**Town of Rotterdam
Planning Commission
April 2, 2024**

1. **GDPL Ville Rotterdam, LLC - 900 & 880 Duanesburg Road.** Preliminary Review for a ±102,725 square foot BJ's Wholesale Club with associated 8 island fueling station at 900 Duanesburg Road and a ±2,300 square foot retail building with associated drive thru. Engineer: ABD Engineers LLC.
2. **RMRCOMP, LLC (Contract Vendee) – 796 Burdeck Street.** Waiver of Site Plan/Special Use Permit Public Hearing to convert an existing ±8,534 square foot office building with warehousing/garage space to a veterinary office with associated kennel, crematorium, and animal hospital. Engineer: ABD Engineers & Surveyors LLP.

Peter Comenzo, Senior Planner
Town of Rotterdam
1100 Sunrise Boulevard
Schenectady, NY 12306

Plan Comments:

PRELIMINARY UTILITIES PLAN

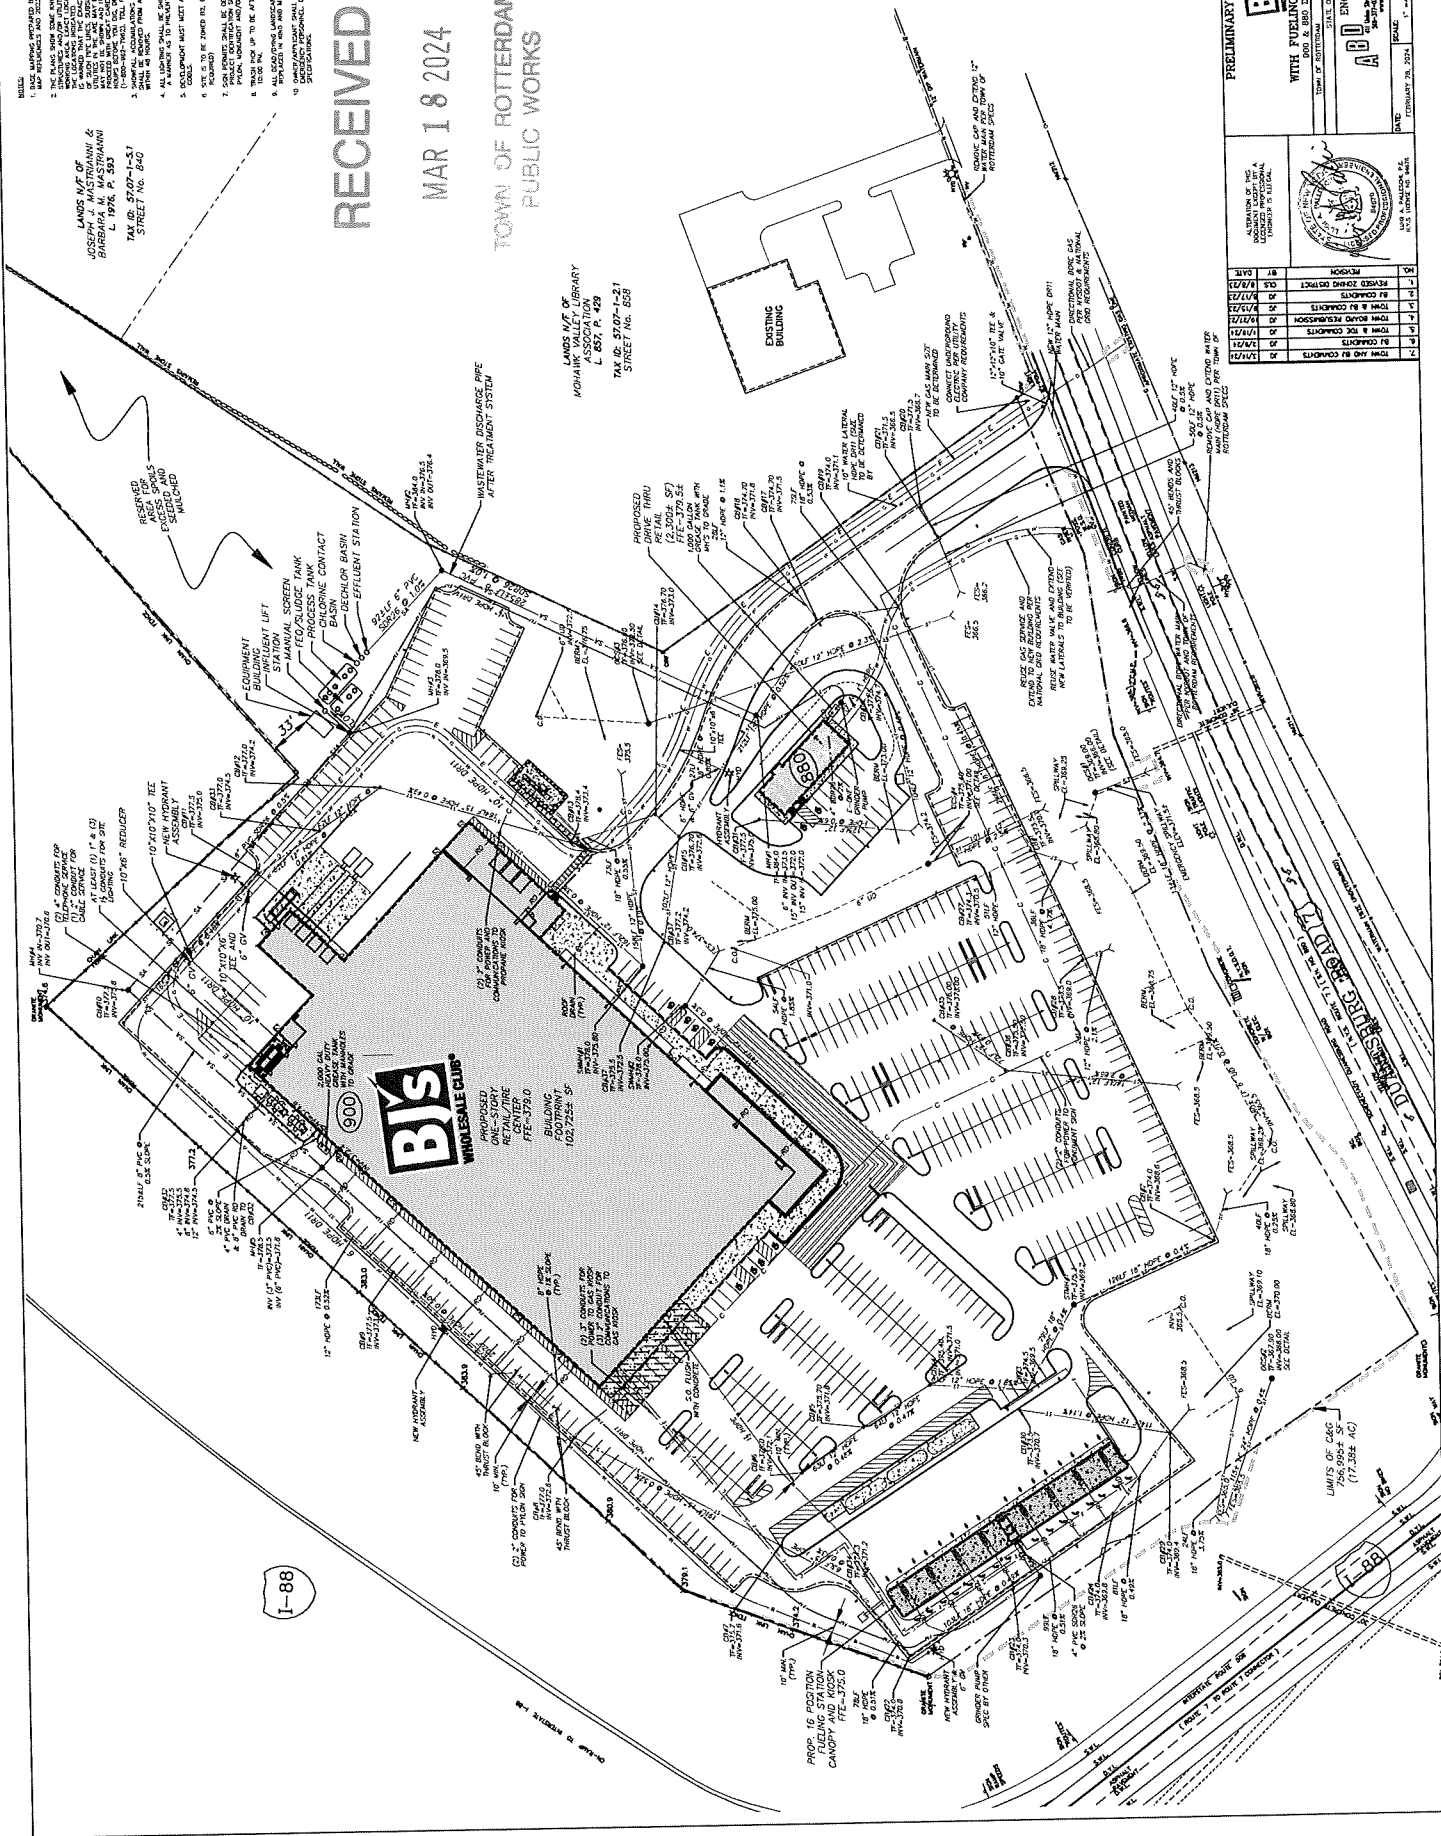
2. *The proposed stormwater network is shown without any reference to other underground utilities, making it difficult to assess the proposed stormwater and other utility piping for conflicts. The Applicant should make sure that all necessary information is shown to make sure the proposed utilities do not have any conflicts with each other. When comparing the utility plan to the grading and stormwater plan, there appear to be a multitude of utility crossings that are not accurately depicted on either of the plans, some of which conflict with each other.*
Stormwater network is now shown on the utility Sheet 6.

19. *The note "10' separation between water and sewer lines" also applies to storm piping which is not shown on the utility plan. The applicant should review the water service line locations relative to the proposed storm network locations and revise their design to meet the separation requirements. Alternatively, the water line can be cased in concrete where separation cannot be reasonably achieved.*
Utility lines have been revised to maintain minimum separation distances.
